Ministry of the Environment

27 May 2013

RE: Application for Class A Quarry Licence - Aggregate Resources Act;
Applicant: Miller Paving Limited, Miller Braeside Quarry, (License Ref. No. 16173),
Part Lots 16 & 17, Concession A, Township of McNab/Braeside (McNab),
County of Renfrew

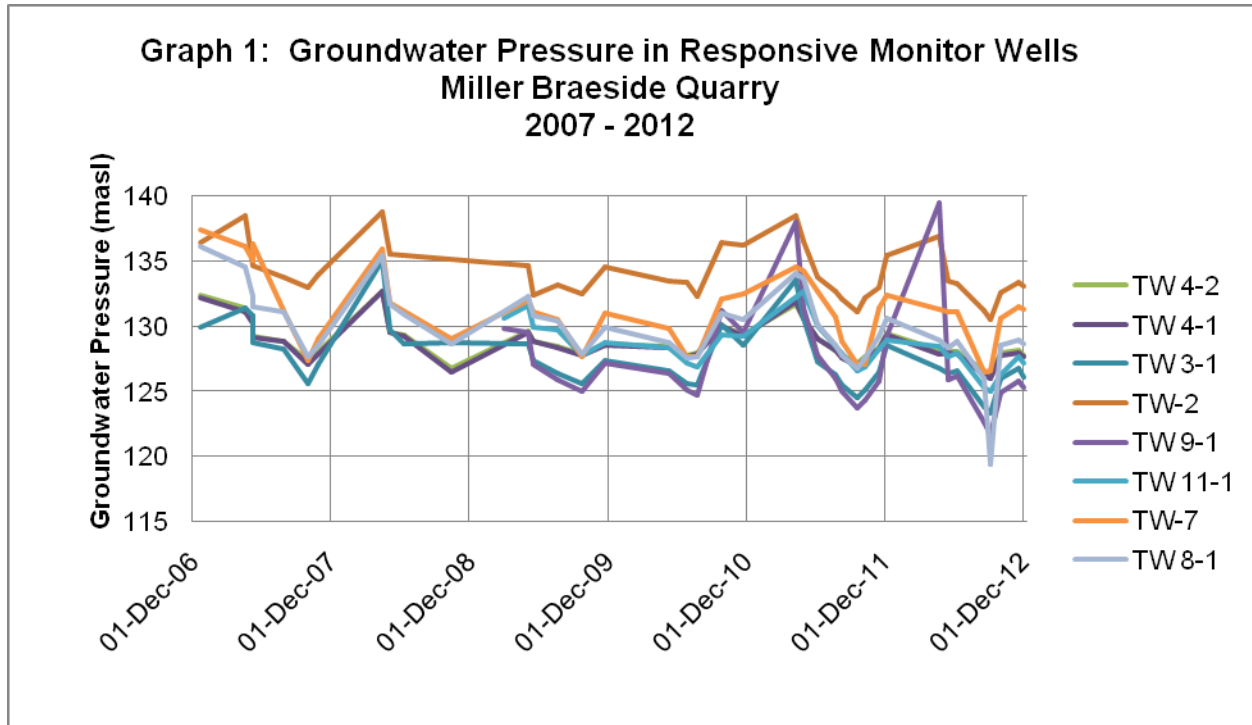
Between 2007 and 2012 multiple monitors concurrently detected groundwater pressure variations on the order of 5 to 10 metres. Graph 1 (below) illustrates the historical variability.

The graph shows a distinct seasonal trend. Highest groundwater pressures typically occur during spring. This corresponds to the annual spring snowmelt period. Lowest ground water pressures typically occur post-summer.

Seasonal variability was negligible in monitors terminating at elevations above 121 masl. The seasonal variability is apparently restricted to monitors intersecting bedrock elevations lower than 121 masl. The highest intersected elevation for this responsive zone was 121.81 masl (TW 8-1). This corresponds to the deeper Gull River Formation.

The responsive monitors are distributed hundreds of metres apart throughout the study area. This suggests that the responsive bedrock layer is locally widespread.

Graph 1 (above) depicts general water pressure elevations in the responsive wells on the order of 130 masl. Gravity flow requires a recharge zone above this level. The aquifer's recharge area probably has the following characteristics:
